SERVICE BULLETIN

1991 LEGACY RIGHT-HAND DRIVE

SERVICE MANUAL CORRECTIONS

1991 SERVICE MANUAL CORRECTIONS

Fig. 1

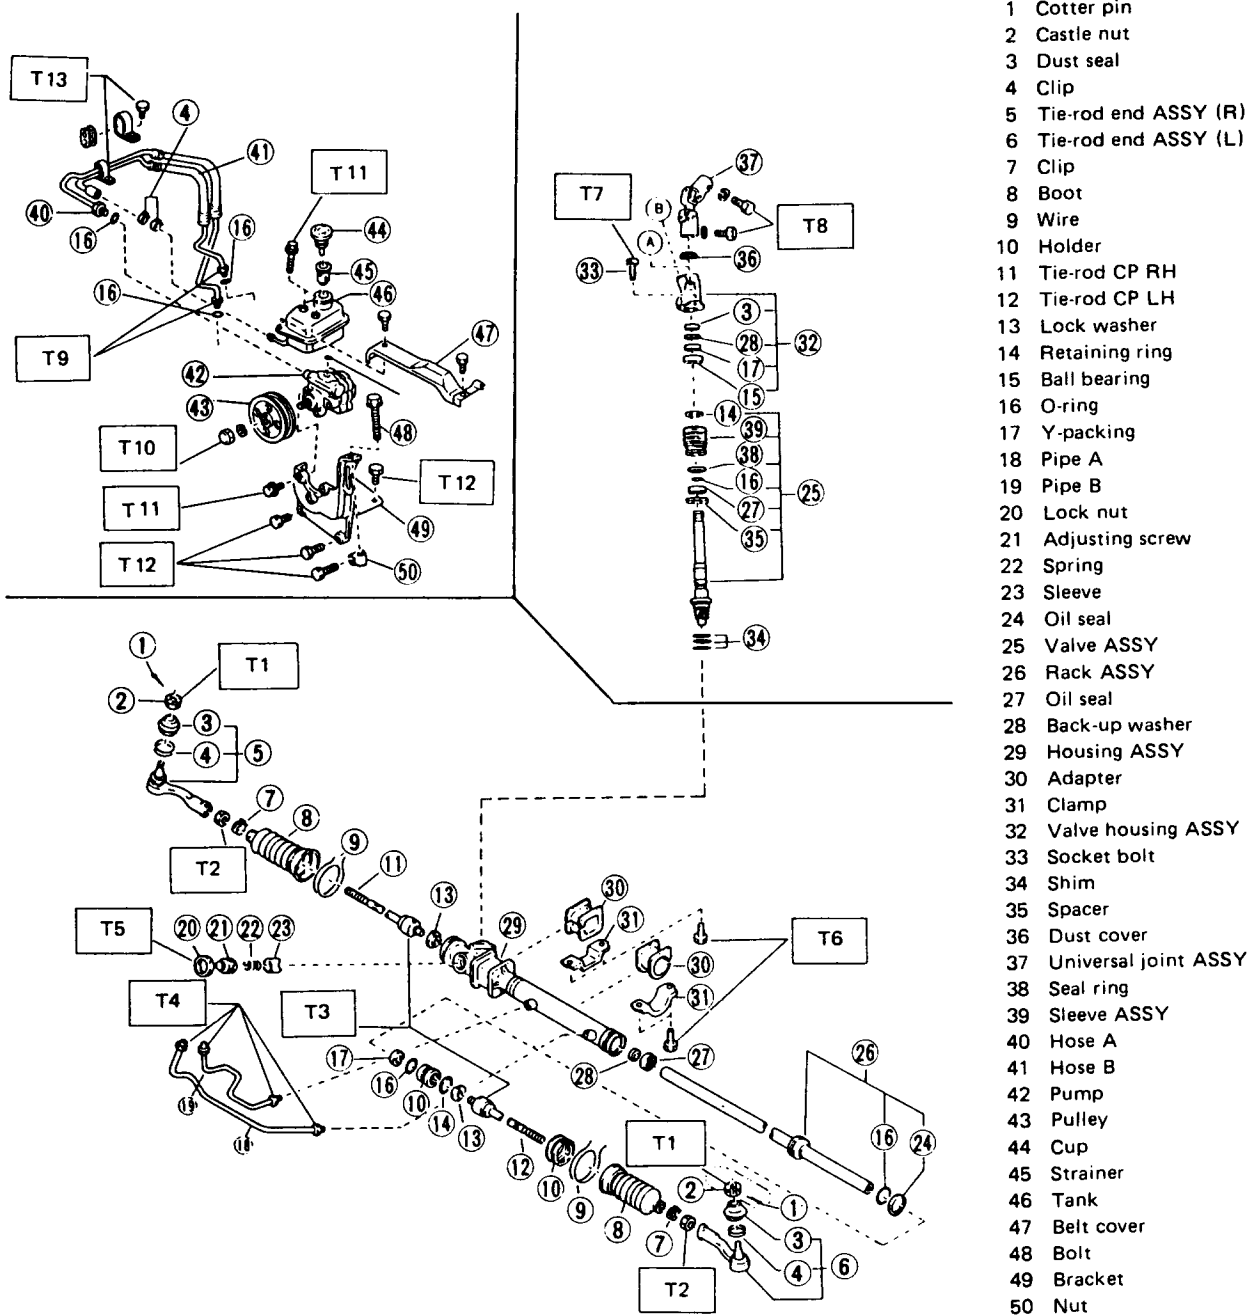
Tightening torque: N·m (kg·m, ft·lb)

T1: After tightening to a torque of 25 to 29 (2.5 to 3.0, 18 to 22), tighten further, by a maximum of 60° until cotter pin holes are aligned.

T2: 78 - 88 (8.0 - 9.0, 58 - 65)

T3: 69 - 88 (7.0 - 9.0, 51 - 65)

T4: 16 - 24 (1.6 - 2.4, 12 - 17)

T5: 29 - 49 (3.0 - 5.0, 22 - 36)

T6: 47 - 71 (4.8 - 7.2, 35 - 52)

T7: 20 - 29 (2.0 - 3.0, 14 - 22)

T8: 21 - 26 (2.1 - 2.7, 15 - 20)

T9: 10 - 20 (1.0 - 2.0, 7 - 14)

T10: 42 - 62 (4.3 - 6.3, 31 - 46)

T11: 18 - 23 (1.8 - 2.3, 13 - 17)

T12: 20 - 24 (2.0 - 2.4, 14 - 17)

T13: 10 - 16 (1.0 - 1.6, 7 - 12)

Fig. 2

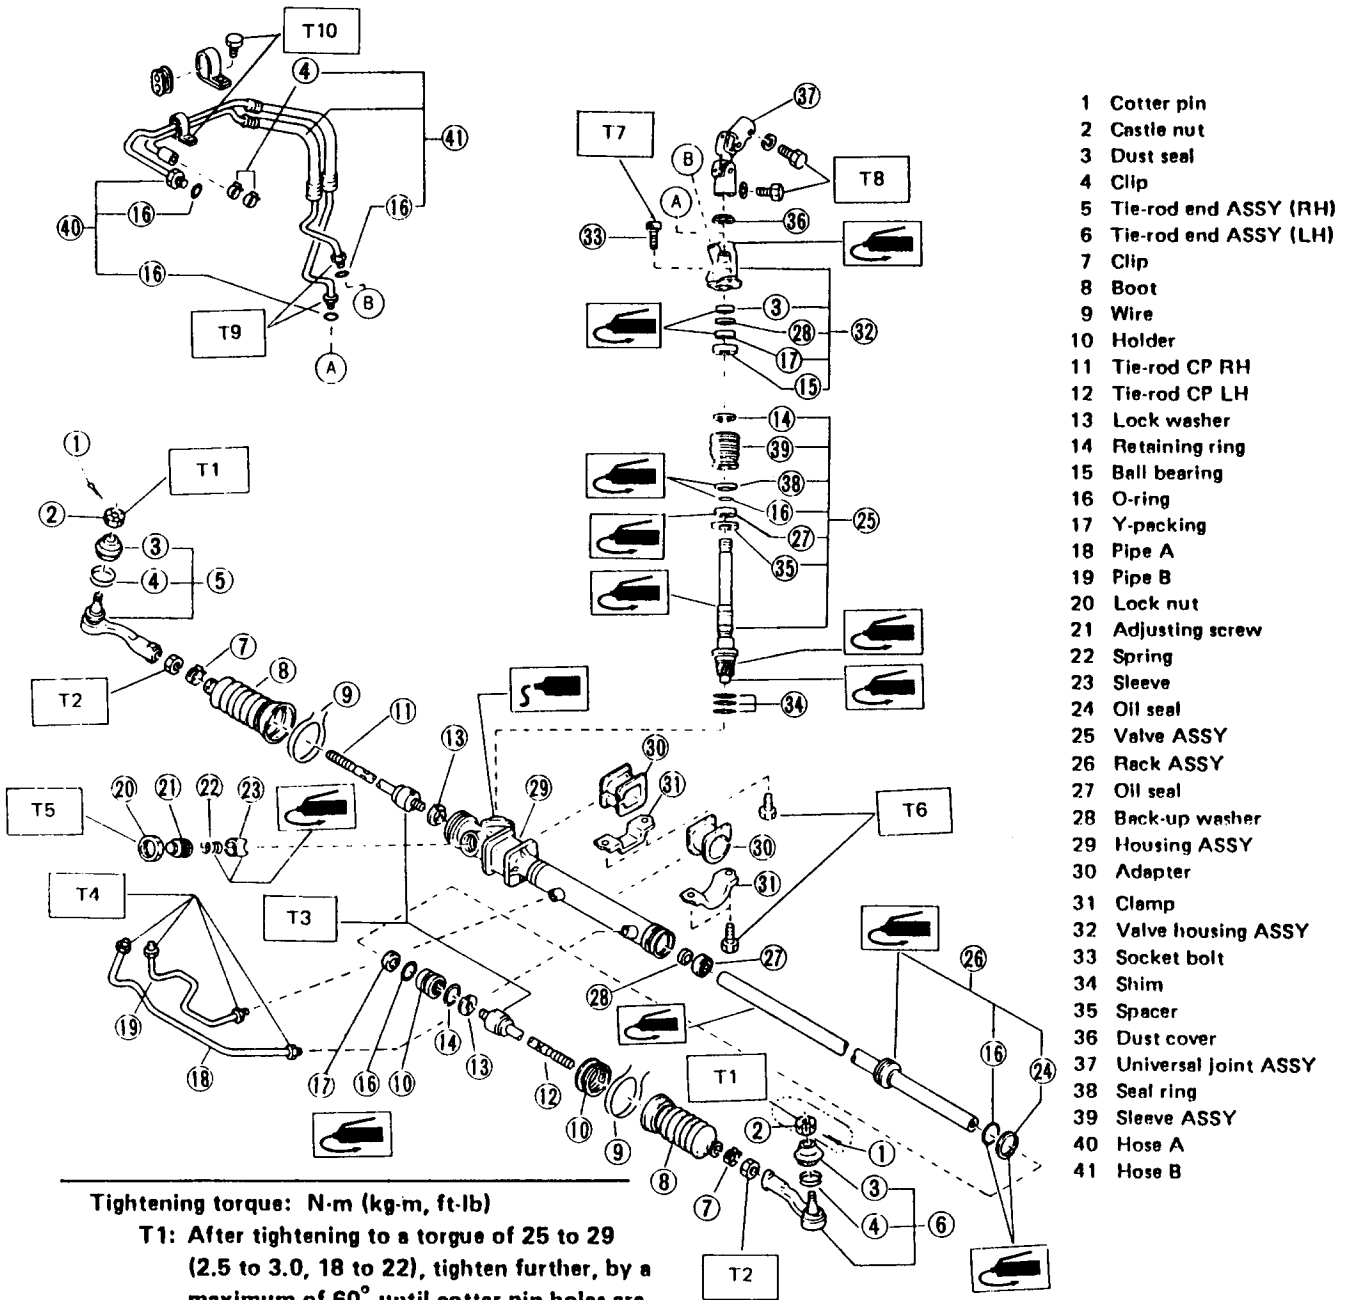
Tightening torque: N·m (kg·m, ft·lb)

T1: After tightening to a torque of 25 to 29 (2.5 to 3.0, 18 to 22), tighten further, by a maximum of 60° until cotter pin holes are aligned.

- T2: 78 - 88 (8.0 - 9.0, 58 - 65)
- T3: 69 - 88 (7.0 - 9.0, 51 - 65)
- T4: 16 - 24 (1.6 - 2.4, 12 - 17)
- T5: 29 - 49 (3.0 - 5.0, 22 - 36)
- T6: 47 - 71 (4.8 - 7.2, 35 - 52)

- T7: 20 - 29 (2.0 - 3.0, 14 - 22)
- T8: 21 - 26 (2.1 - 2.7, 15 - 20)
- T9: 10 - 20 (1.0 - 2.0, 7 - 14)
- T10: 10 - 16 (1.0 - 1.6, 7 - 12)

Fig. 30

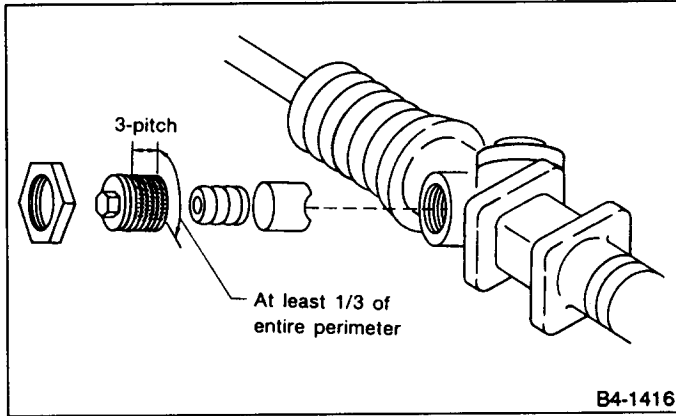
7) Rack & pinion backlash adjustment

- (1) Loosen adjusting screw.
- (2) Rotate input shaft so that rack is in the straight ahead direction. [Ensure that distance between rack end and stopper is 72.4 mm (2.850 in) .]
- (3) Apply liquid packing to at least 1/3 of entire perimeter of adjusting screw.

● While rotating input shaft to fully move rack shaft to the left and right, ensure that rack moves smoothly without binding, and that rotating torque is constant.

Fig. 31

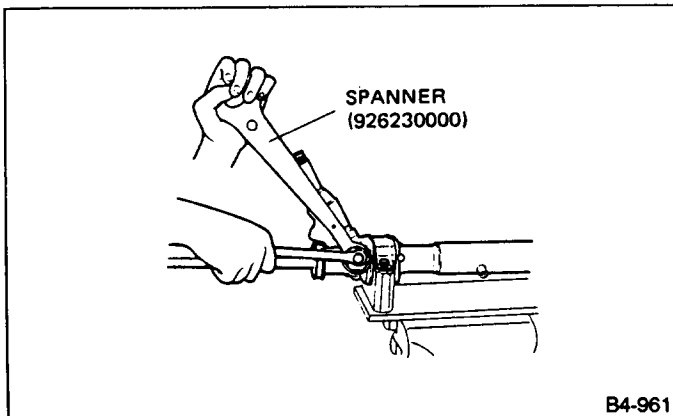
- (4) Install adjusting screw.
- (5) Repeatedly tighten and loosen adjusting screw two or three times until sleeve settles down.

- (6) Tighten adjusting screw to 5 N•m (0.5 kg-m, 3.6 ft-lb) and then loosen by 30°.

- (7) While holding adjusting screw using a closed wrench, tighten lock nut using SPANNER.

Tightening torque:

29 — 49 N•m (3 — 5 kg-m, 22 — 36 ft-lb)

Fig. 79

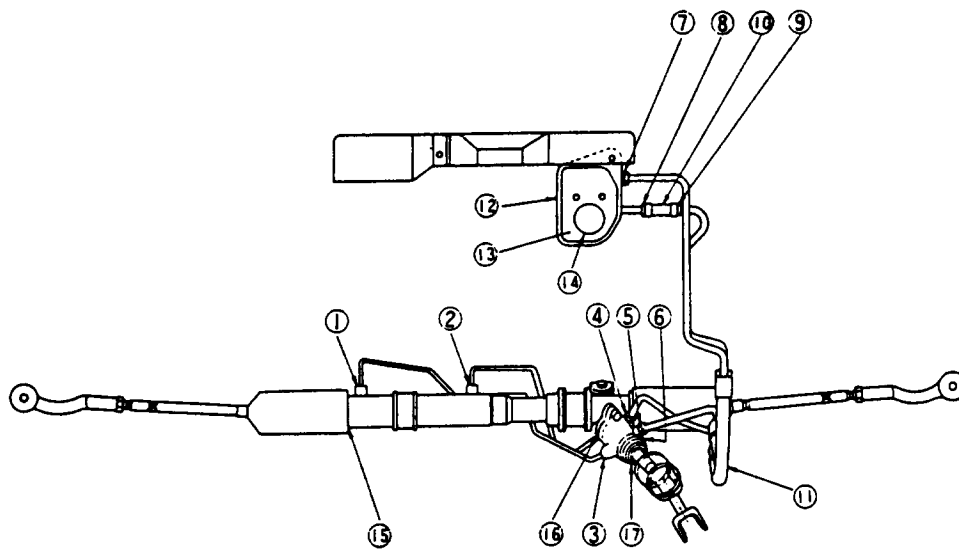
It is likely that although one judges fluid leakage, there is actually no leakage. This is because the fluid spilt during the last maintenance was not completely wiped off. Be sure to wipe off spilt fluid thoroughly after maintenance.

Severe operation of vehicle may cause fluid to ooze out at air vent in cap. However, this is not a problem.

Wipe clean spilled fluid after servicing.

Fig. 80

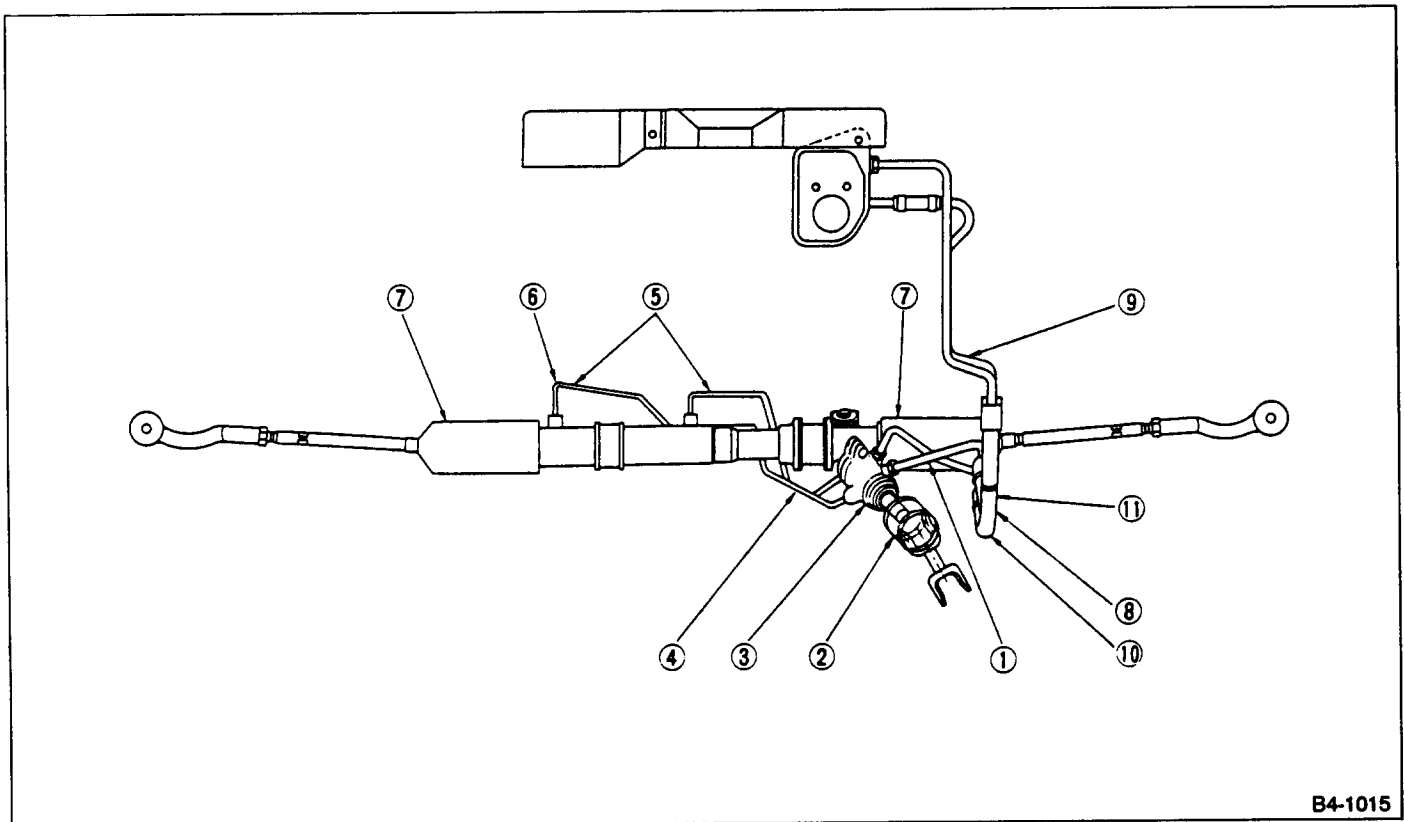
This table lists various clearances that must be correctly adjusted to ensure normal vehicle driving without interfering noise, or any other faults.

No.	Location	Minimum clearance mm (in)	No.	Location	Minimum clearance mm (in)
①	Pipe-to-pipe clearance of crossmember and hose ASSY and pipe-to-pipe clearance of hose ASSY	5 (0.20)	⑦	Exhaust pipe-to-gearbox boot clearance	18 (0.71)
②	DOJ-to-shaft and DOJ-to-joint clearances	14 (0.55)	⑧	Side frame-to-hose clearance	15 (0.59)
③	DOJ-to-valve housing clearance	11 (0.43)	⑨	Blow-by hose-to-hose clearance	5 (0.20)
④	Pipe-to-pipe and pipe-to-crossmember clearance	2 (0.08)	⑩	Master cylinder-to-hose clearance	20 (0.79)
⑤	Stabilizer-to-power steering feed pipe clearance	5 (0.20)	⑪	Cruise control pump-to-hose clearance	12 (0.47)
⑥	Exhaust pipe-to-power steering feed pipe clearance	15 (0.59)
